Rezoning Transportation Analysis

Petition Number: 2022-147

General Location Identifier: 17901179, 17901184

Date	Description
1-25-23	First Review (IW)
2-22-23	Second Review (IW)
03-22-23	Third Review (IW)
04-25-23	Fourth Review ZC (IW)

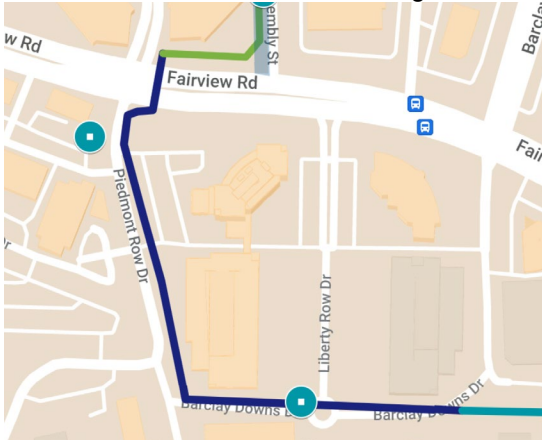
- 3. ~~**Outstanding Comment from 1-25-23** Revise site plan and conditional note(s) to commit to dedicate 63 feet of right of way from the Fairview Road centerline. The site plan shall label and dimension the right of way from the road centerline.~~

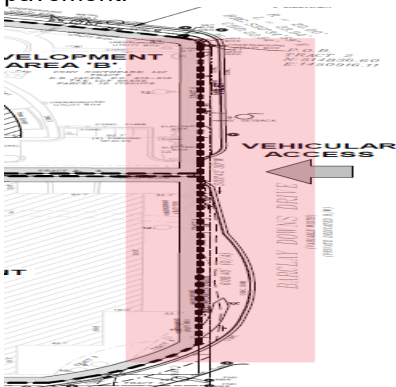
4. ~~Revise site plan and conditional note(s) to commit to constructing The LOOP standard 12 foot sidewalk along the portion of the property frontage where The LOOP is designated to be constructed. As shown below, The LOOP path is along the southern portion of Barclay, goes North on Piedmont Row Drive, and crosses Fairview at the existing crosswalk.~~

5. ~~Revise site plan and conditional note(s) to commit to construct an 8-foot planting strip, and 12-foot Multi-Use Path on Fairview Road to support the City Council adopted Charlotte Streets map, and to meet the Council adopted Charlotte BIKES Policy. Multi-use paths maintained by the City shall meet ADA/PROWAG requirements. The site plan shall label and dimension both items from the back of curb and gutter or edge of pavement.~~

Clarifying Comment 2-22-23: ~~Update conditional note V.e. under Transportation to state “Sidewalks may meander to preserve existing conditions where approved by CDOT and Urban Forestry.~~

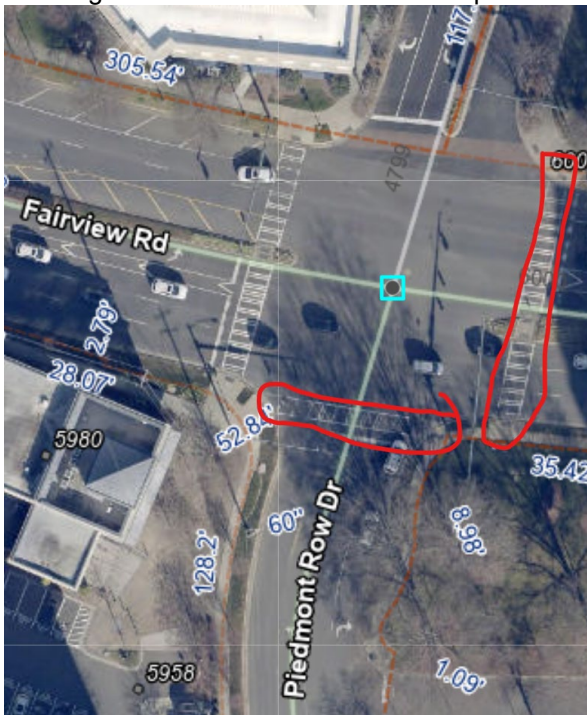
8. ~~Per coordination and request of The LOOP project team: revise site plan and conditional note(s) to commit to install LOOP branded furniture within property boundary that includes 2 benches and a bike rack near intersection of Piedmont and Fairview within Development Area "A". The LOOP project team has already purchased the furniture, the request is for the developer to install it.~~
